PHASE 2 - CHRIS P  
11/4 + 12/4 (M)

R19391  
Daveney

Viborg

Col. VIB-004 (C/Maman)

Cut Plan ① 775 x 500

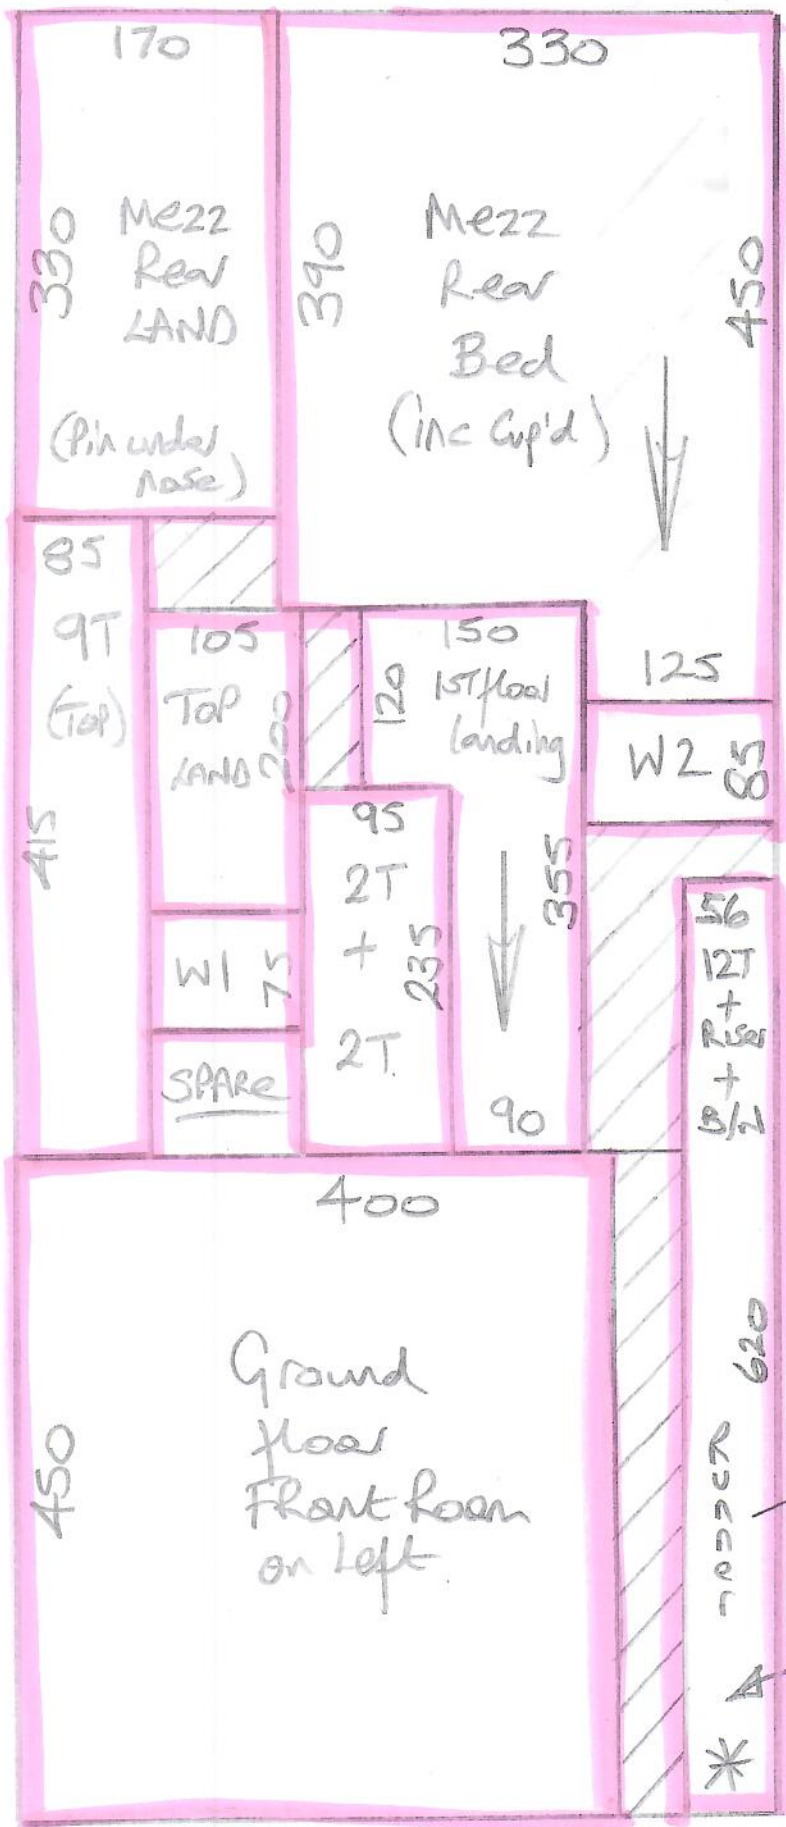
Cut Plan ② 460 x 500

Cut Plan ③ 1200 x 500

ORDERED 1 Roll  
@ 2500 x 500

LOFT BEDROOM

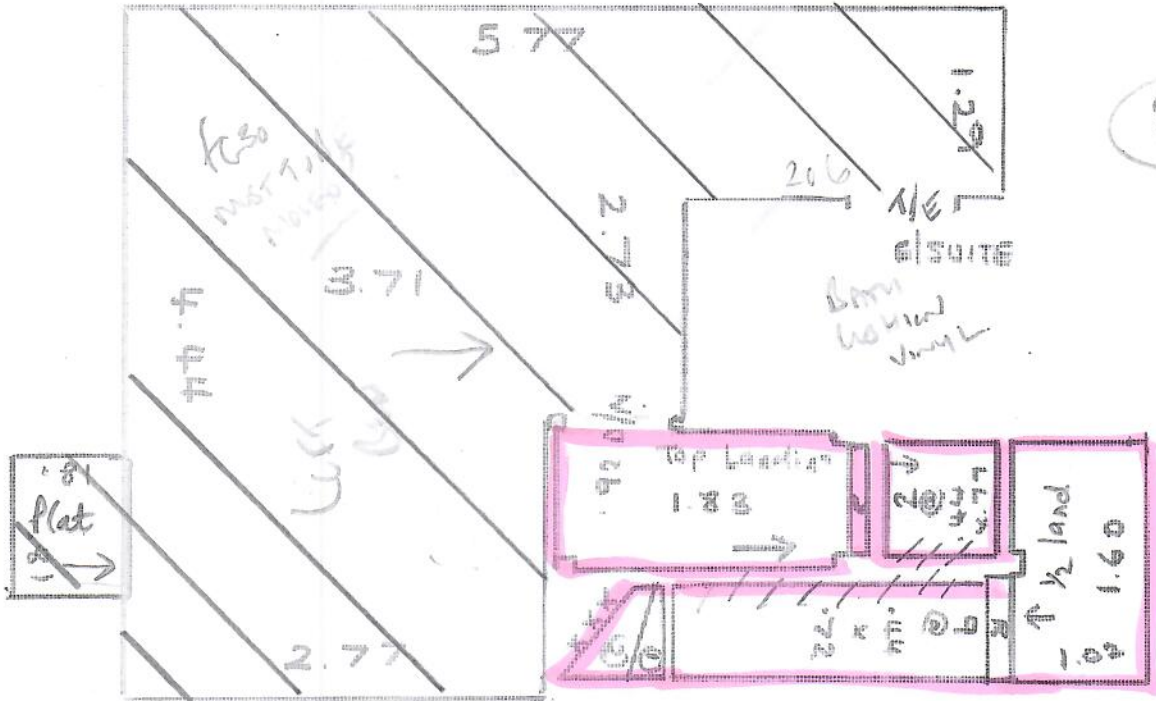
W1 = .62 x .81  
W2 = .78 x .10

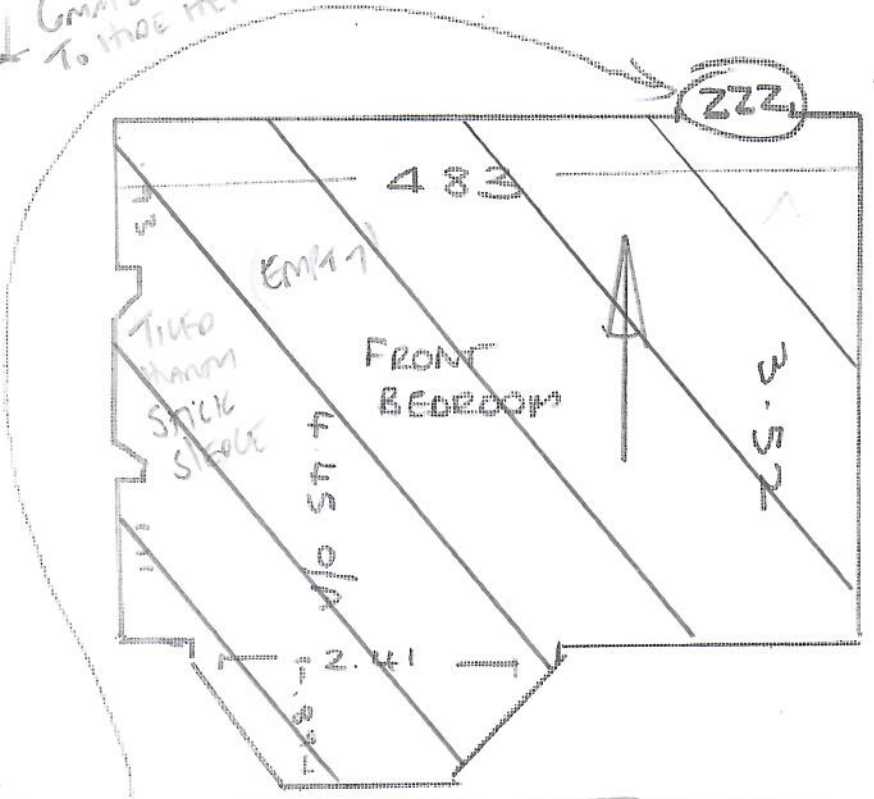
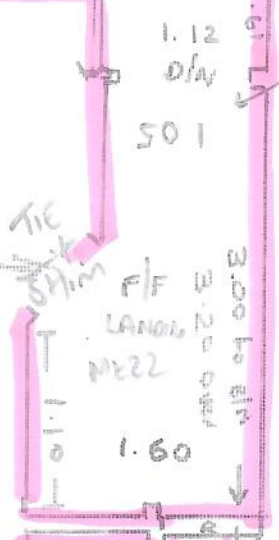
Plywood needs securing down

Crown Moulding? To those there - Difference here

THIS DOOR NEEDS CUTTING

Spindles open side

THIS IS A LEDGE THAT WILL BE PAINTED ✓

CHECKED WITH KATHLEEN 11/2/24

GROUND FLOOR  
LEFT FRONT ROOM

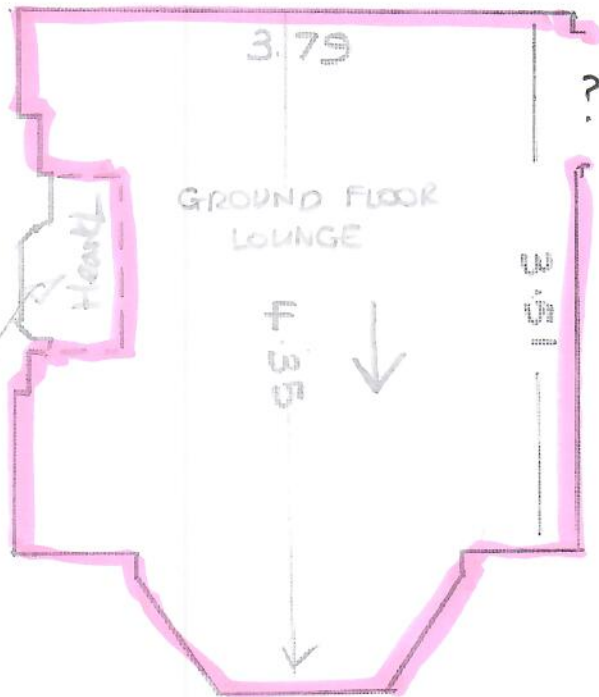
\* SKIRTING WAS 22mm gap (must have had wood floor)  
(Builders to lay plywood to entire room to build up height)

This fine hearts to be tiled  
will need a trim around it  
of same sort (Tbc).
